HISTORIC AND DESIGN REVIEW COMMISSION

HDRC CASE NO: 2020-347
COMMON NAME: 255 BRAHAN
LEGAL DESCRIPTION: NCB 3856 (255 BRAHAN {AMENDING}), BLOCK 2 LOT 26 & 27
ZONING: RM-4, H
CITY COUNCIL DIST.: 2
DISTRICT: Westfort Historic District
APPLICANT: Cy Goudge
OWNER: PEP Capital
TYPE OF WORK: Construction of two, 2-story, multi-family residential structures
APPLICATION RECEIVED: August 03, 2020
60-DAY REVIEW: Not applicable due to City Council Emergency Orders
CASE MANAGER: Edward Hall
REQUEST:

The applicant is requesting conceptual approval for the general footprint, setbacks and massing of two, 2-story, multi-family residential structures at 255 Brahan, located within the Westfort Historic District.

CONCEPTUAL SITE PLAN

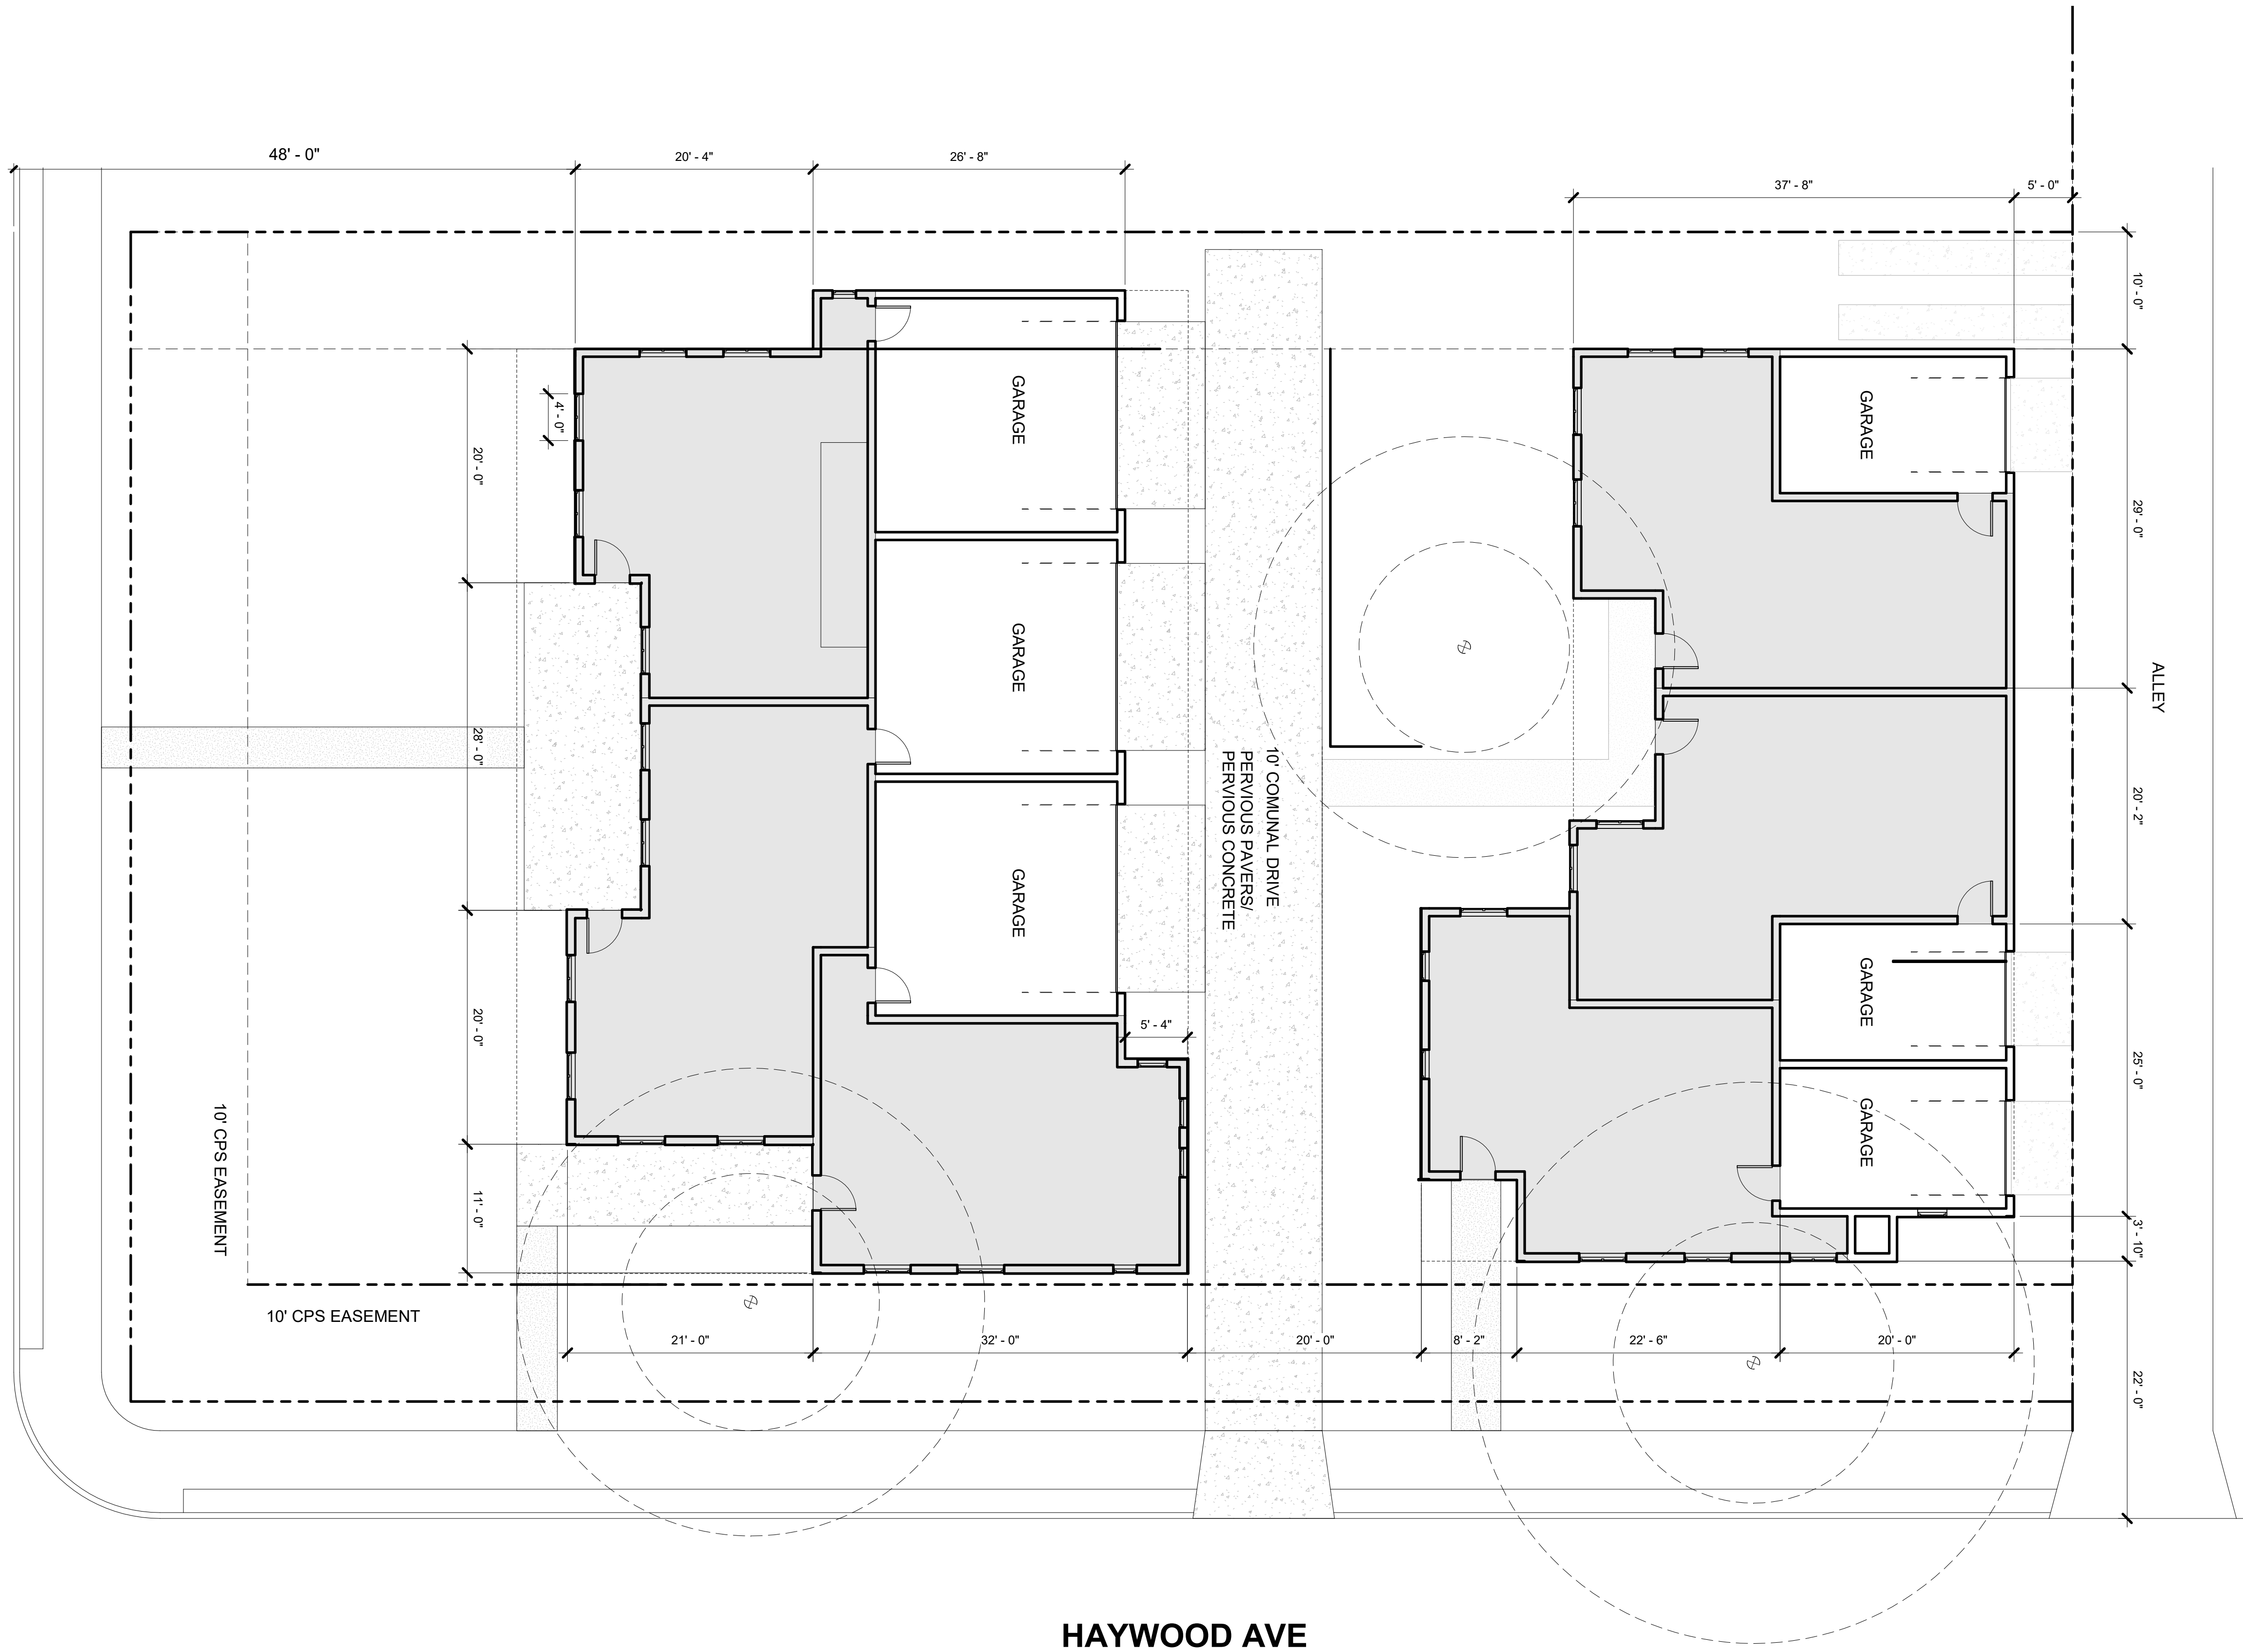
- e. **SETBACKS & ORIENTATION (Brahan)**– Regarding setbacks, the applicant has proposed for the structures facing Brahan to feature a setback of forty-eight feet from the street to the front façade, not including the porch and porch roof.. Regardless of the measured setback, staff finds that the proposed new construction should feature setbacks on both Brahan that are equal to or greater than those of the adjacent historic structures. This should be demonstrated by submitted a site plan that includes the existing structures on each block.

- f. **SETBACKS & ORIENTATION (Haywood)** – The applicant has proposed setbacks of twenty-one (21) and twenty-two (22) feet on Haywood Avenue. Regardless of the measured setback, staff finds that the proposed new construction should feature setbacks Haywood that are equal to or greater than those of the adjacent historic

structures. This should be demonstrated by submitted a site plan that includes the existing structures on each block.

- g. LOT COVERAGE – Per the Guidelines for New Construction 2.D.i., applicants should limit the building footprint for new construction to no more than 50 percent of the total lot area, unless adjacent historic buildings establish a precedent with a greater building to lot ratio. Per the submitted site plan, it appears that the applicant’s proposal is consistent with the Guidelines. The applicant has noted forty-seven (47) percent impervious cover.

- p. DRIVEWAY – The applicant has proposed a driveway with access from Haywood into the interior of the site. The applicant has noted a driveway width of ten (10) feet. This is consistent with the Guidelines.

- r. WALKWAYS – Per the submitted site plan, the applicant has proposed a walkway to connect the front porch of the front structure to the sidewalk at the public right of way, parallel to Brahan. This is consistent with the Guidelines. Staff finds that a similar walkway should connect to Haywood.

- i. That the applicant provide a site plan that include the adjacent historic structures to provide context and confirm that the proposed setbacks on both Brahan and Haywood are appropriate, as noted in findings e and f.

- vi. That the applicant adhere to the materials and window standards noted in the applicable citations and in findings m and n.
- vii. That the applicant include a walkway on Haywood and connect the recommended entrance elements to the sidewalk at the right of way, as noted in finding r.

DRAWING TITLE:
AXONIMETRIC

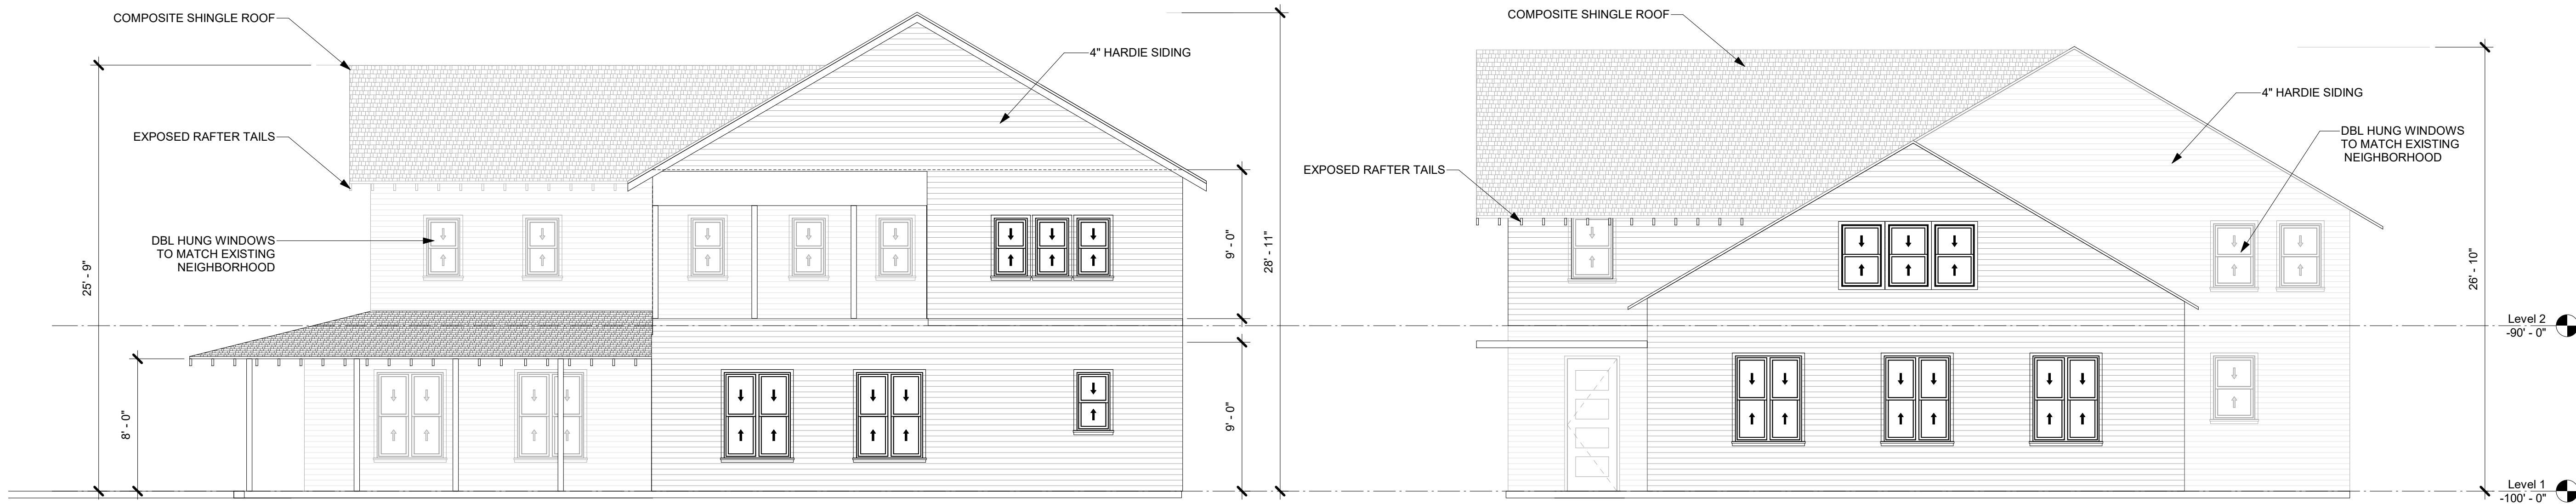
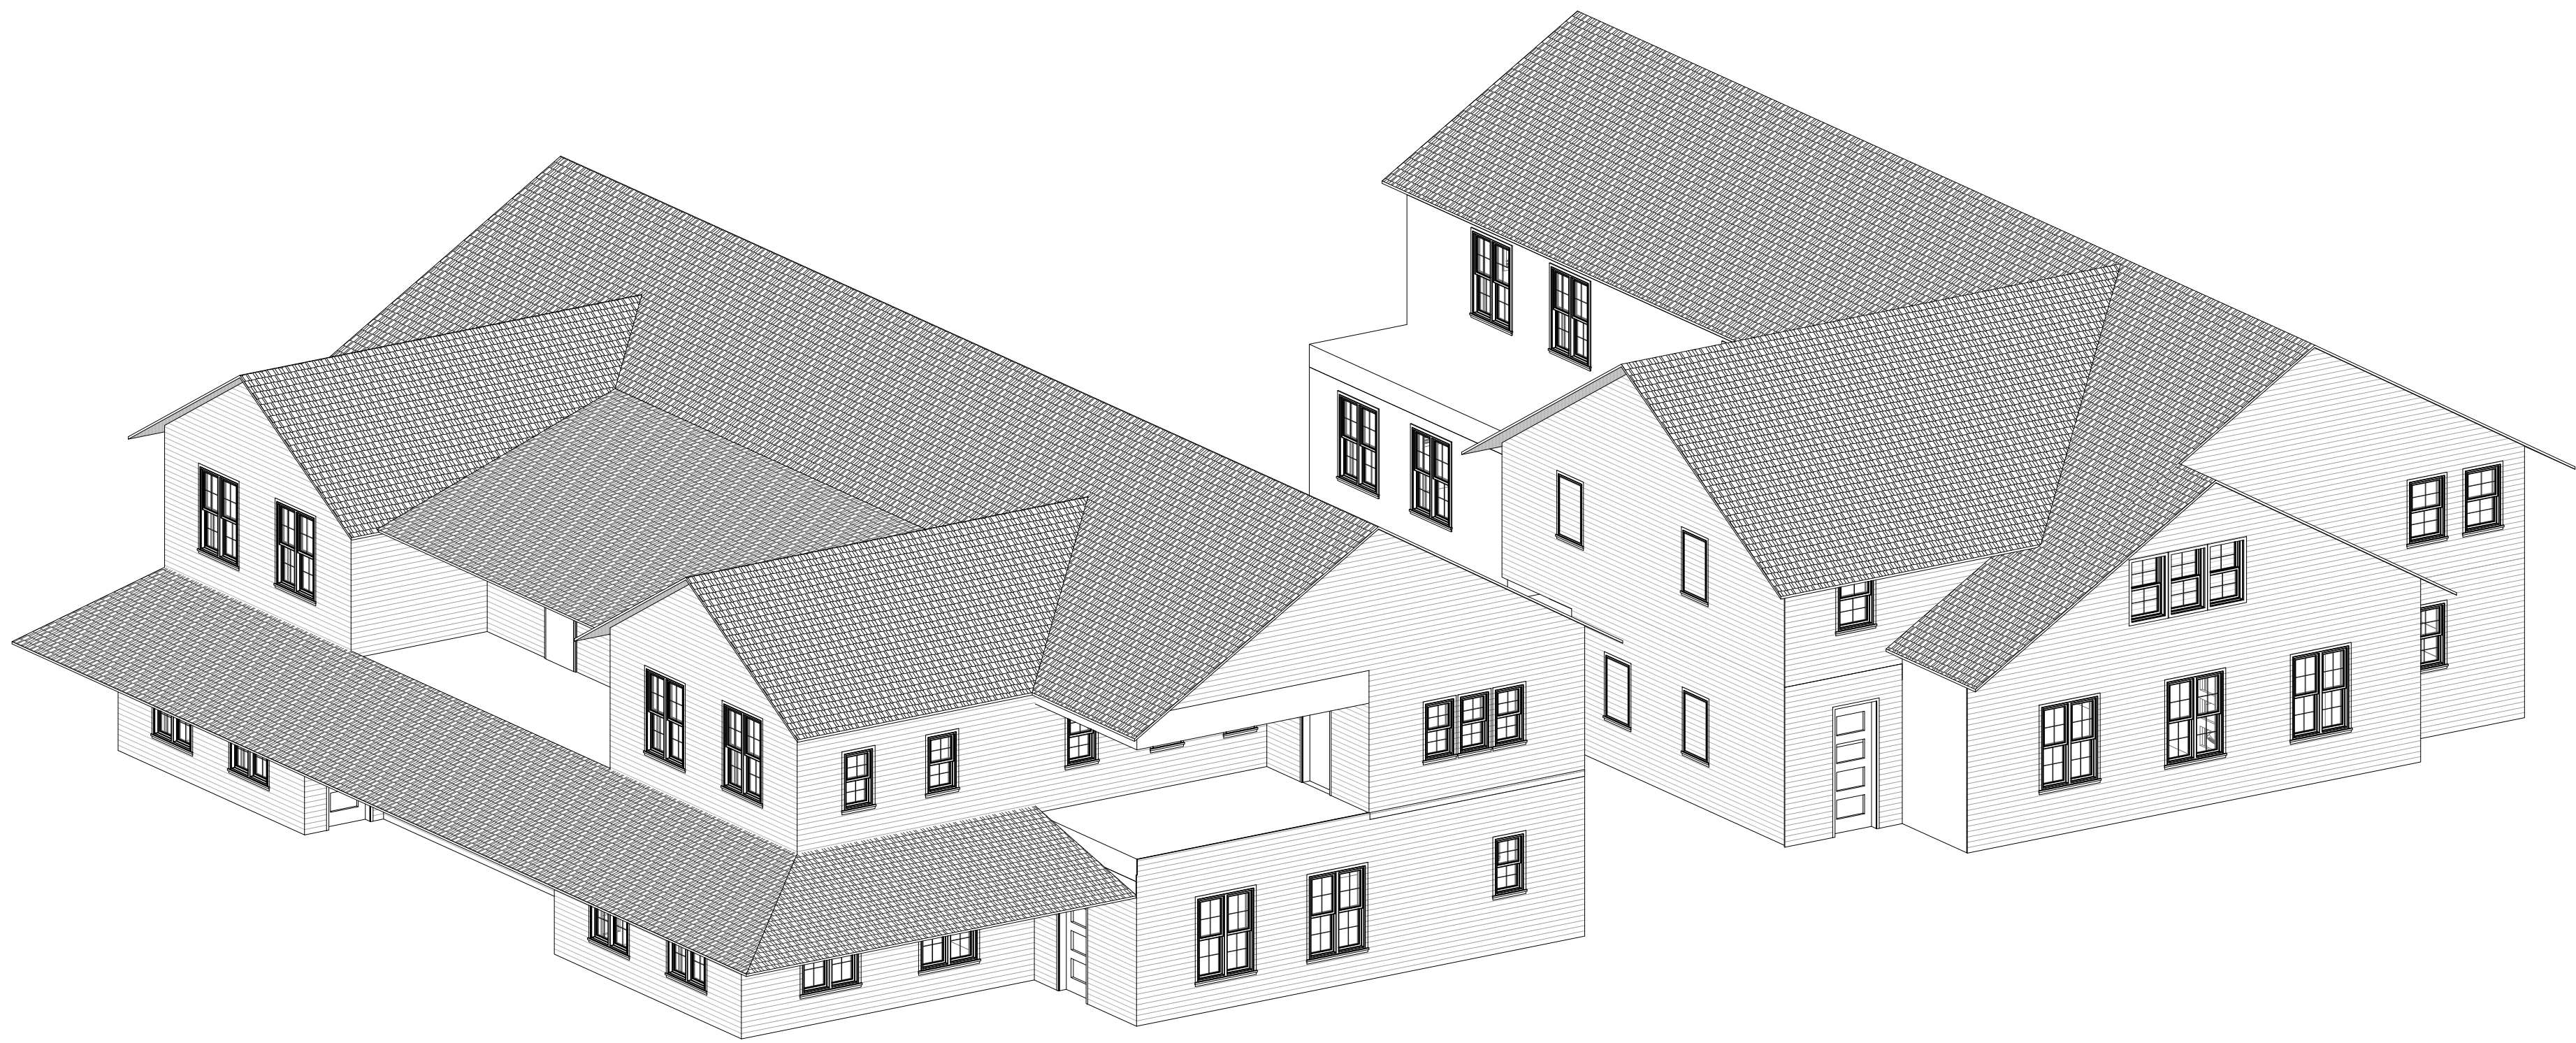
- i. SCALE & MASS (Width) – The applicant has proposed for both the front and rear structures to feature overall widths of approximately eighty (80) to eight-four (84) feet in width. Both of the proposed widths are considerably wider than building widths found historically within the district. The applicant has separated the massing of both structures be incorporating a number of setbacks and projecting massing elements. While staff finds this to be generally appropriate; staff finds that the proposed widths are not. Staff finds that building widths should be reduced.

- j. ENTRANCE ELEMENTS – According to the Guidelines for New Construction 1.B.i., primary building entrances should be oriented towards the primary street. The applicant has oriented entrances of the southern structure to front Brahan; however, no door currently faces Brahan. Staff finds that a door should be installed toward Brahan, consistent with the historic examples found on the block. Additionally, staff finds that the rear structure should feature entrance elements that address Haywood. Entrance elements should include massing and architectural elements consistent with the front façade of a historic structure.

- l. ROOF FORMS – The applicant has proposed both front and side facing gabled roofs, both of which are consistent with the Guidelines and historic examples found within the district; however, staff finds that the overall roof massing is atypical of those found historically within the district due to its overall size.

- m. MATERIALS – The applicant has noted on the conceptual elevations that composite siding with a four inch exposure will be installed. Staff finds that all siding should feature a four (4) inch exposure, a thickness of ¾”, mitered corners and a smooth finish. Columns should be six inches square, and window materials should meet staff’s standards for windows in new construction.

- ii. That the applicant reduce the overall width of both structures as noted in finding i.
- iii. That the applicant incorporate entrance elements and entrance massing to address Haywood for the rear structure, as noted in finding j. Additionally, staff recommends that entrances be incorporated into the Brahan facing façade.

- iv. That the applicant utilize foundation and floor heights that are consistent with the Guidelines as noted in finding k.
- v. That the applicant reduce the overall massing of the proposed roof, consistent with the reduction in width, as noted in finding l.
